**ORDINANCE NO. 5089**

**AN ORDINANCE APPROVING A LANDSCAPE PLAN AND STREET TREE PLAN FOR THE BAKER CREEK NORTH SUBDIVISION**

**DECISION, CONDITIONS, FINDINGS OF FACT AND CONCLUSIONARY FINDINGS FOR THE APPROVAL OF A LANDSCAPE PLAN AND STREET TREE PLAN FOR THE BAKER CREEK NORTH SUBDIVISION**

**DOCKET:** L 12-19 (Tree Removal, Landscape Plan and Street Tree Plan)

Figure 4. Proposed Street Tree Plan

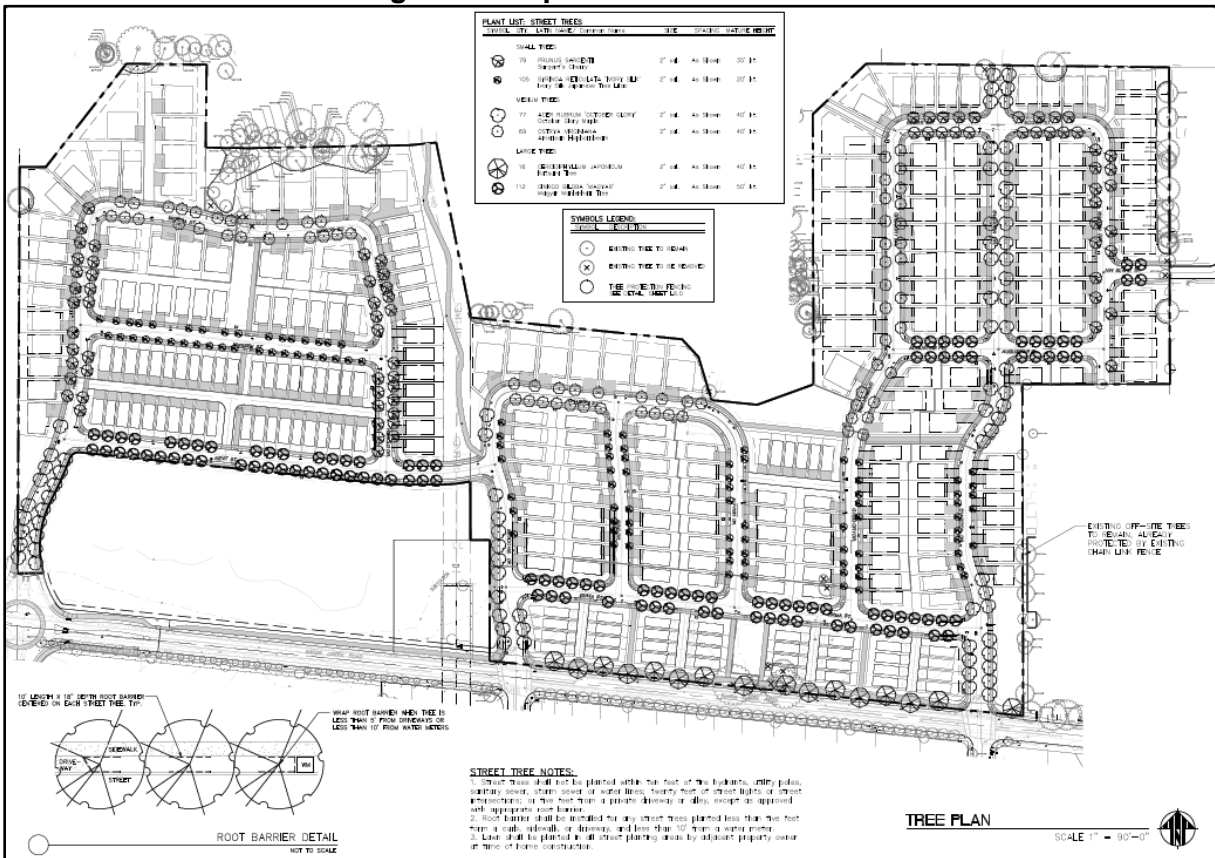
5. That only the 17 existing trees identified for removal on Drawing L1.0 Street Tree Plan shall be approved for removal.
  6. That landscaping be provided for Sewage Pump Station Tract 'G'. Landscaping shall be provided at an amount equal to or greater than 25 percent of the gross area of the tract, and shall provide screening of the pump station structure from surrounding properties.

5. That only the 17 existing trees identified for removal on Drawing L1.0 Street Tree Plan shall be approved for removal.
6. That landscaping be provided for Sewage Pump Station Tract 'G'. Landscaping shall be provided at an amount equal to or greater than 25 percent of the gross area of the tract, and shall provide screening of the pump station structure from surrounding properties.

- iv. *Ostrya virginiana* (American Hophornbeam)
    - v. *Prunus sargentii* (Sargent Cherry)
15. That street trees in addition to those shown on the Street Tree Plan dated 11/18/2019 shall be provided in the following locations, unless a utility is present that creates a setback requirement:

**CONDITION FOR FINDING:** That only the 17 trees identified for removal on Drawing L1.0 Street Tree Plan shall be approved for removal.

Pump Station 'Tract G':

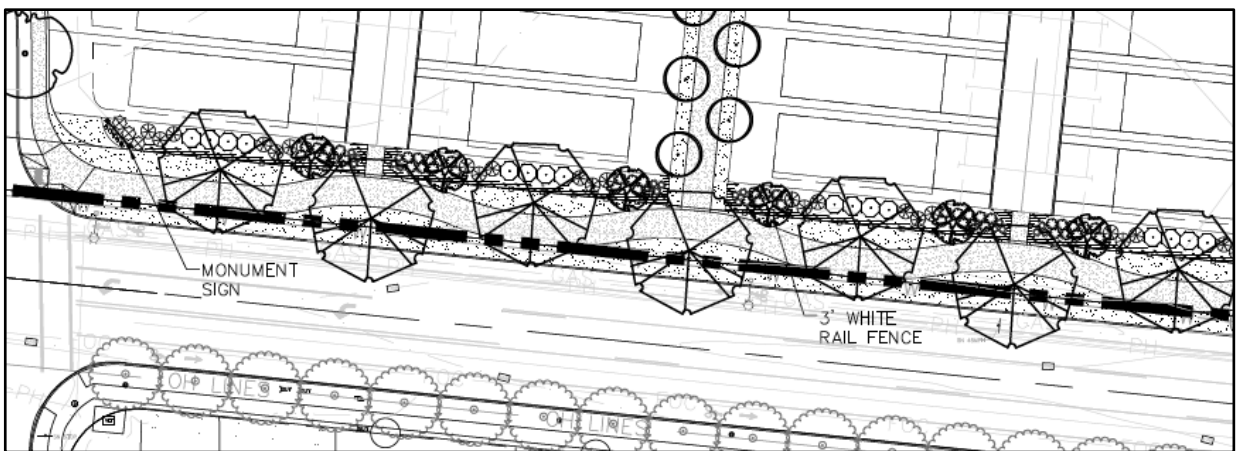
**CONDITION FOR FINDING:** That landscaping be provided for Sewage Pump Station Tract 'G'. Landscaping shall be provided at an amount equal to or greater than 25 percent of the gross area of the tract, and shall provide screening of the pump station from surrounding properties.

Landscaping was not proposed for Tract G at the intersection of Charles Street and Alfred Drive, where a sewer pump station is located. Tract G is adjacent to residential lots 60, 109, and 110, and is across the street from lots 49, 111, and Open Space Tract F. There is no screening or buffering of the pump station from the adjacent residential uses. A condition of approval requiring landscaping to screen and buffer the sewage pump station has been included.

Open Space 'Tract I':

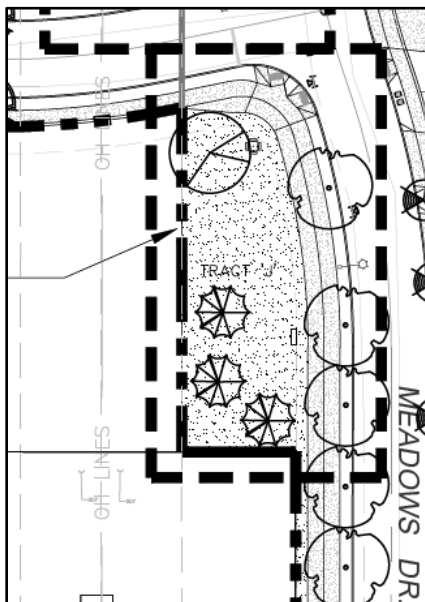
Based on comments from McMinnville Water & Light, trees surrounding the electric substation should be limited in height to 25 feet. A condition is included limiting the height of any trees located in Open Space Tract I to a maximum mature canopy height of 25 feet.

Open Space 'Tract J':

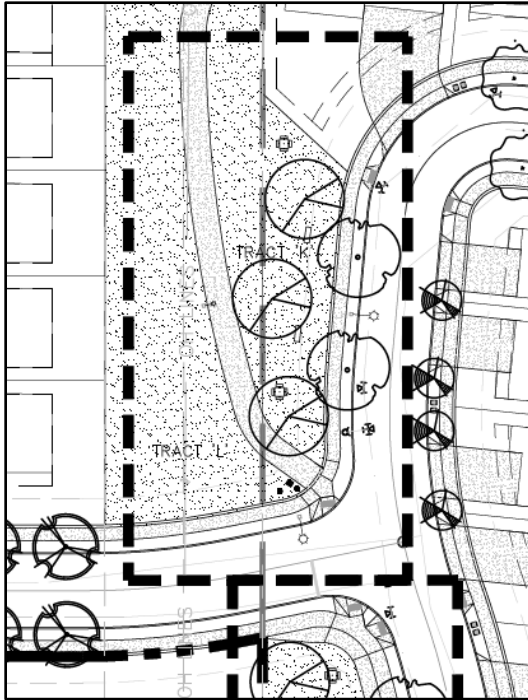
Douglas Fir trees can grow to approximately 100 feet tall and 30 feet wide, and Sunburst Honey Locust grow to approximately 40 feet tall and wide. Based on comments from McMinnville Water & Light, trees surrounding the electric substation should be limited in height to 25 feet. Additionally, trees adjacent to the transmission easement should be limited in height 40 feet and located such that no canopy encroaches into the transmission easement. A condition is included limiting the height of any trees in Open Space Tract J adjacent to the electric substation to a maximum mature canopy height of 25 feet, and no tree in Tract J shall

exceed a maximum mature canopy height of 40 feet or be located such that no canopy encroaches into the transmission easement.

Open Space 'Tract K':

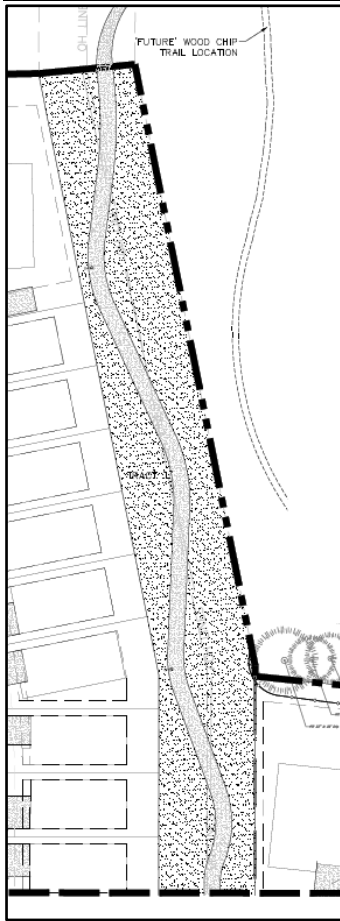
Sunburst Honey Locusts grow approximately 40 feet tall and wide. Based on comments from McMinnville Water & Light, trees in Tract K should be located such that no canopy encroaches into the transmission easement. A condition is included limiting the height of any trees in Open Space Tract K to a maximum mature canopy height of 40 feet and to locations such that no canopy encroaches into the transmission easement.

Open Space & Access Easement 'Tract L':

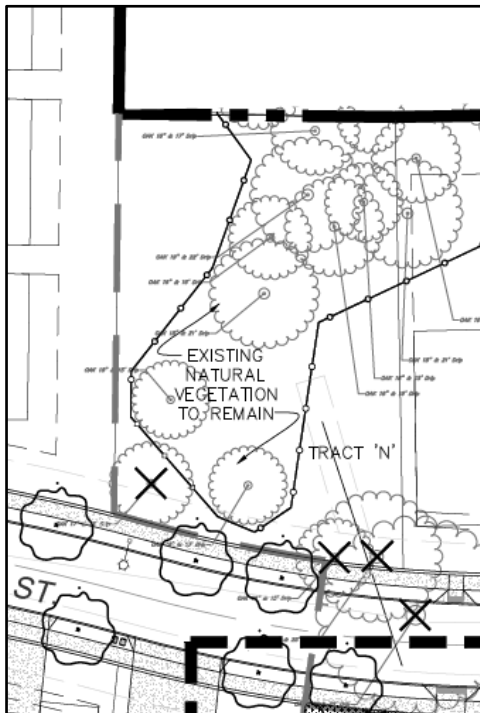
- Tract L: shows an offset 10' gravel pathway, and turf for a portion of the tract. The remaining portion is labelled as "existing grass field to remain", with a 10' gravel pathway. This is not similar to the existing BPA pathway design as per earlier discussion, and does not provide an accessible surface for pedestrians.

Tract L is the northernmost extension of the Westside Bicycle/Pedestrian Greenway through the planned development and BPA easement, leading to the proposed park dedication. A 10 foot wide multi-use trail is proposed, meandering through an open lawn area below overhead electric transmission lines. Because of the overhead lines, trees in the Access Easement are not recommended. Based on McMinnville Water & Light comments, conditions of approval are included to restrict the placement of trees inside Open Space & Access Easement Tract L, limiting the height of any trees in adjacent to Tract L to a maximum mature canopy height of 40 feet and to locations such that no canopy encroaches into the transmission easement, and to ensure no picnic table or other public amenity blocks access to transmission facilities.

Additionally, no street trees should be located within the public right-of-way in the transmission line easement, where they would be in incompatible with electrical transmission lines overhead.
